STAFF REPORT

To: Southeast Consolidated Zoning Board
Fr: Pamela Hayhow, AICP, Senior Planner
Re: Application Nos. SE 19-20-REZ and 19-21-PDP (AU)

Requested Action: 1) Rezoning from RUR, Rural District, to PRUR, Planned Rural District; and
2) Preliminary Development Plan (preliminary plat) for 5 residential lots to be known as Adams Farm

Figure 2: Aerial view with regulatory floodplain (left) and preliminary development plan (right)

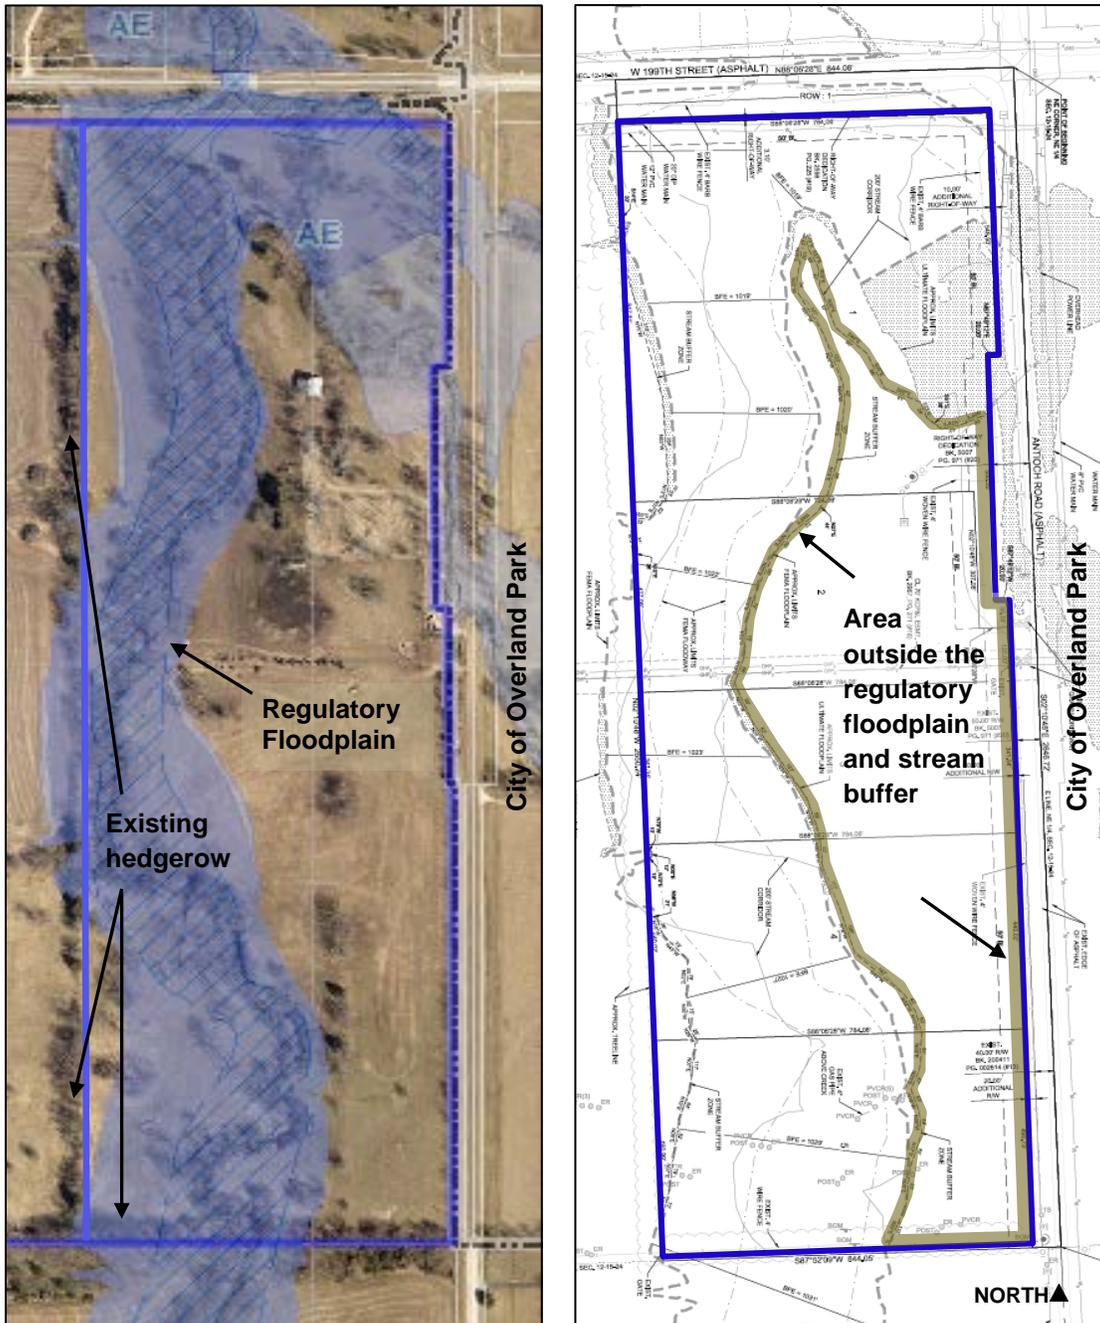
The applicant is requesting a waiver to allow the lots in the proposed subdivision with PRUR zoning to access directly onto Antioch Road, a CARNP designated Arterial Street. NOTE: All lots, except Lot 2, are shown with more than 330 ft. of frontage on Antioch Road, the minimum frontage required for access directly by lots in new subdivisions with standard RUR zoning.

At 16 acres, lot 1 is the largest lot but it contains the most floodplain and stream buffer. Proposed access to lot 1 is from the existing driveway which served the former farmhouse. The existing driveway is south of the regulatory floodplain, and along what would be the street frontage for lot 2 if the side lot lines were extended straight toward Antioch Road. Because access to lot 1 angles across the corner of lot 2, lot 2 has a lot width (measured at the front building line) and street frontage of 120 ft. which does not meet the minimum 150 ft. lot width for the PRUR district or the minimum 330 ft. of frontage required for a driveway to a CARNP designated Type 1 Arterial Street. In addition, lot 2 is less than 10 acres in size so the maximum lot-depth to lot-width ratio is 3 to 1; lot 2 with a lot width of 120 ft. and a lot depth 784 ft has a lot-depth to lot width ratio of 6.5 to 1.

With the exception of Lot 2, all of the lots meet the minimum subdivision standards. Use of the flexibility allowed in the PRUR district is appropriate because: 1) there are natural features which are unique to the subject property; 2) compared to an allowed subdivision design in the standard RUR district, the proposed subdivision does not increase the overall density or propose more driveways than would be allowed with 2,644 ft. of frontage on a CARNP designated Type 1 Arterial Street; and 3) the purpose of the lot-depth to lot-width ratio is to avoid "piano key" shaped lots and the lot width of lot 2 increases to over 400 ft. within a short distance of the existing driveway – not a "piano key" shape.

- 1) Overland Park would not allow floodplain or stream corridor to be part of individual lots. Common ownership and maintenance requirements for the corridor would be required.

- 2) Proposed Lot 1 - this is a tricky area for lot - we would require that a driveway serving the lot be elevated so that there would not be more than 7 inches of water depth during a flood event. Culverts would be required and possibly guardrails. The home site should be carefully placed; the minimum low opening should be elevated and stream meander should be accounted for. Identification of the allowed buildable area is recommended.

- 3) It is unclear what zoning district is being requested. Does lot 2 meet minimum lot width/street frontage requirements?
- 4) 60 feet of half street right-of-way should be acquired for 199th and Antioch.

- 5) The City's [Official Street Map](#) has identified a round about as the future intersection improvement at 199th and Antioch. Additional right-of-way is required to accommodate a future round about. See attached example from Century Farms.

Staff recommends **approval** of the rezoning the subject property from RUR, Rural District, to PRUR, Planned Rural District and **approval** of the associated preliminary development plan (preliminary plat), subject to stipulations.

Staff recommends **approval** of a waiver from the Minimum Infrastructure Requirements for Roads to allow direct access onto Antioch Road.

Staff recommends **approval** of a waiver from the Minimum Infrastructure Requirements for Wastewater Disposal to allow the developer to not provide dry sewers.

1. The following notes shall be added to the preliminary and final development plan plat:
 - a. "This Plat has lots considered to be Development Projects, and therefore is subject to a fee in lieu of park dedication in the amount of \$ _____ (1% based on the fair market value), in accordance with the requirements of Johnson County Resolution No. 046-94."

2. Final Stormwater Management and Stormwater Quality Management Plans shall be submitted with the application for the final development plan (final plat).

3. The applicant will coordinate with Water One regarding fire hydrant location(s) and will submit a plan with the application for the final development plan (final plat) for review by the Chief Building Official.

4. Provide certification that all existing blanket easements have been absolved or are shown in a defined boundary prior to approval of the final development plan (final plat).

5. All existing and new utility easements shall be shown on the final development plan (final plat).
 6. Revised preliminary and final development plans (plats) shall be submitted prior to recording the revised final plat.
